PWSCC in u-bends at Indian Point

Review of Westinghouse POD Claims

Profile of Tube 2-67 of steam generator 24

Figure 1 Depth and voltage profile of the crack in tube 2-67 of steam generator 24 located in 1997.

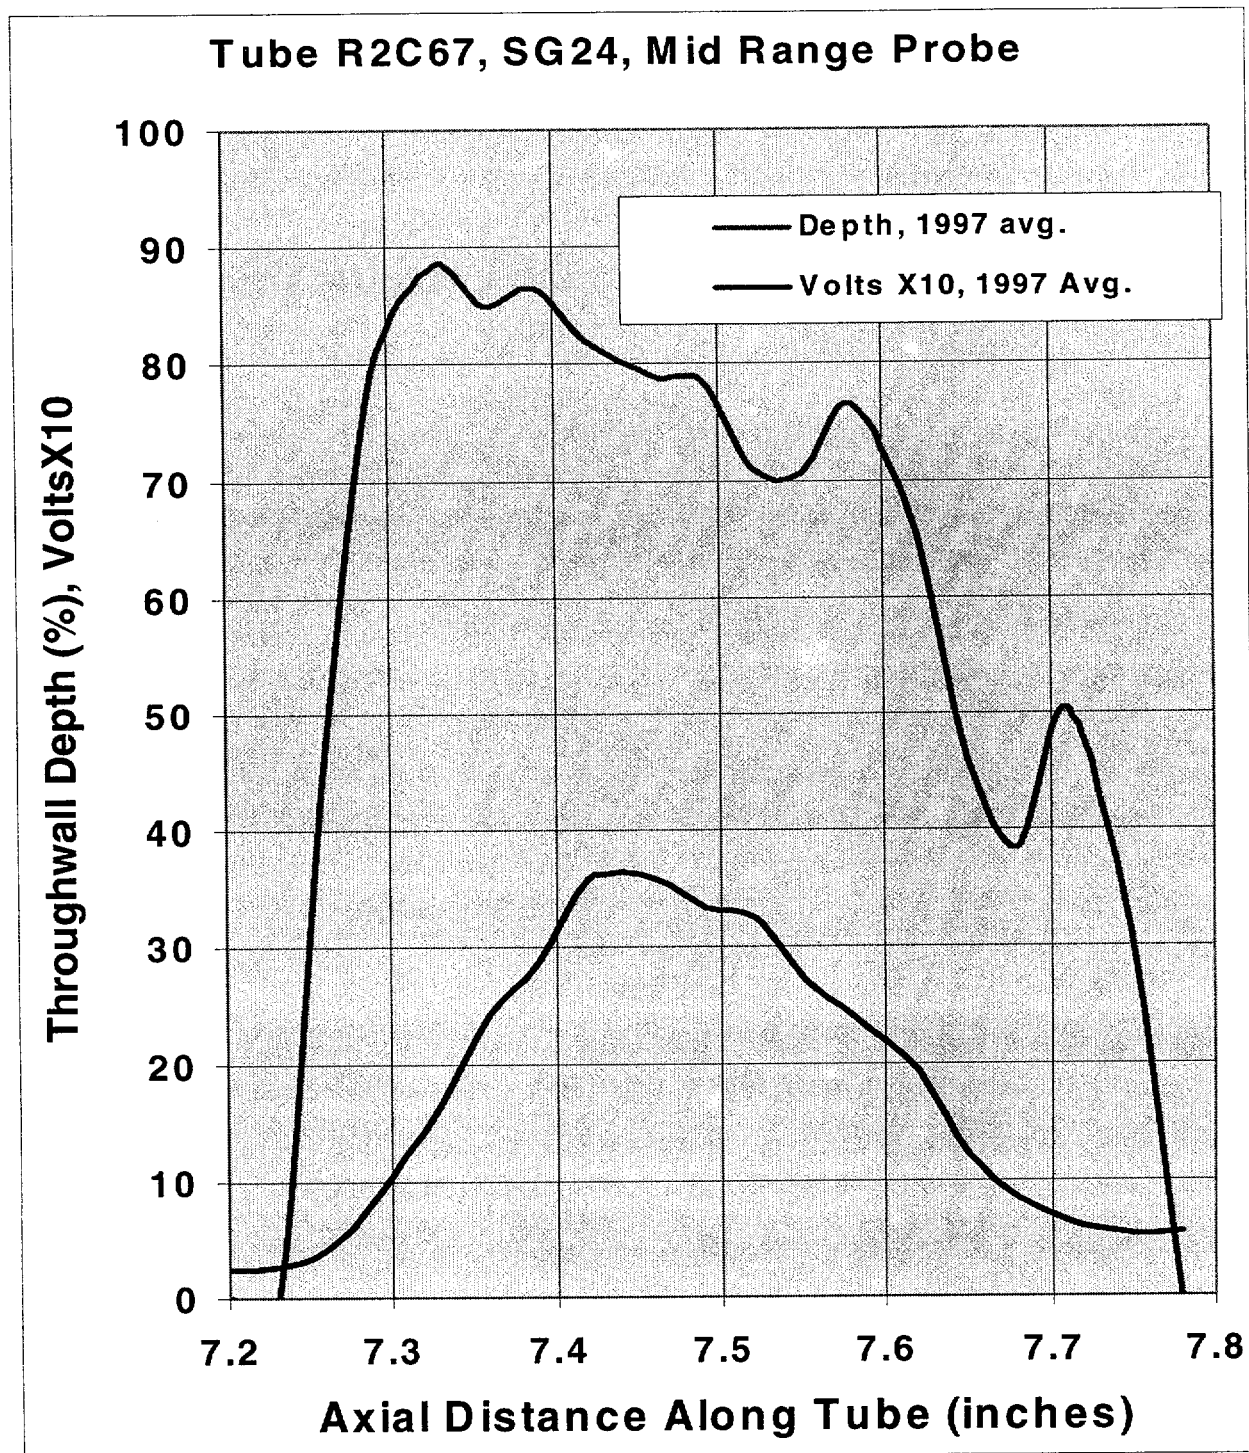
The profile of tube 2-67 is shown in Figure 1. The estimated length is about 0.35-inches. The

depth is the average of the 300 kHz and the 400 kHz readings. The crack measures about 80% deep at the maximum voltage reading, typically where the depth is measured in field evaluations. The voltage amplitude of this signal is about 3.5 volts, which is about 65% of that of an 80% EDM notch.

Figure 2 Crack in tube 2-67 of steam generator 24, found in 1997.

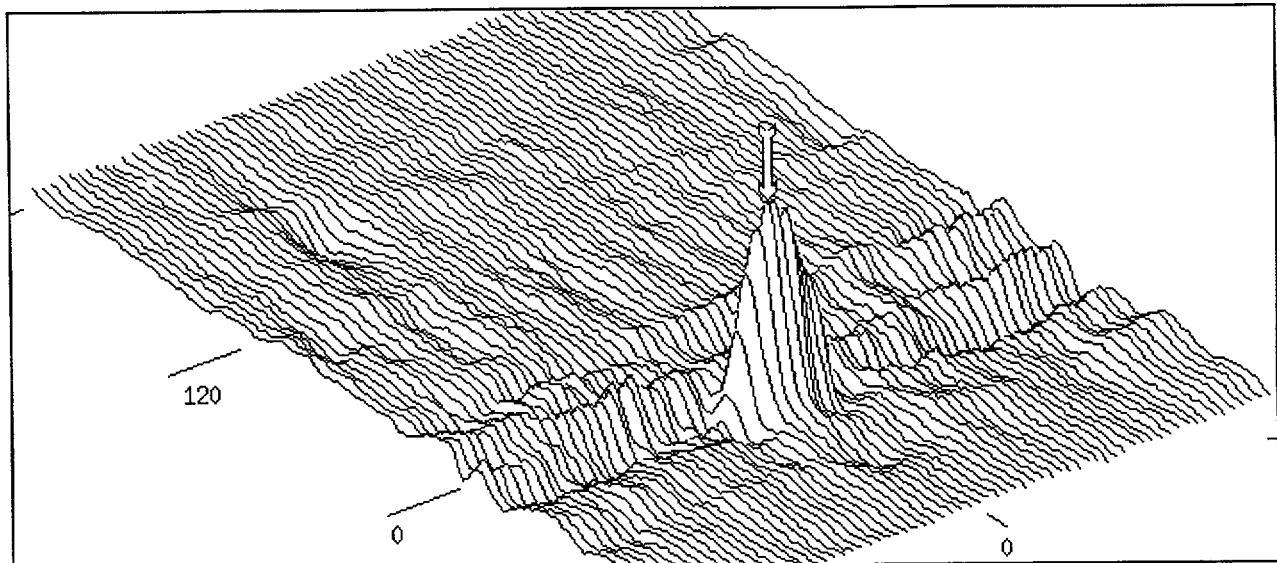
The c-scan of this tube is shown in Figure 2. The crack sits beside a ridge, in a valley, and is in an easily detectable portion of the tube. The large amplitude of the voltage signal, in relation to

the standard calibration notch would indicate that this is a “mature” crack. The growth pattern of the other cracks at this plant shows that the voltage amplitude grows more than the crack depth. Many of the cracks profiled from data at this outage had a poor signal-to-noise ratio, which introduced a large uncertainty in the measurement of the crack depth. However, that is not the case with this crack. There has not been any “adjustment” on the profile of this crack, such as Westinghouse does in their profiling. This is not normally done in the field evaluation of crack depth.
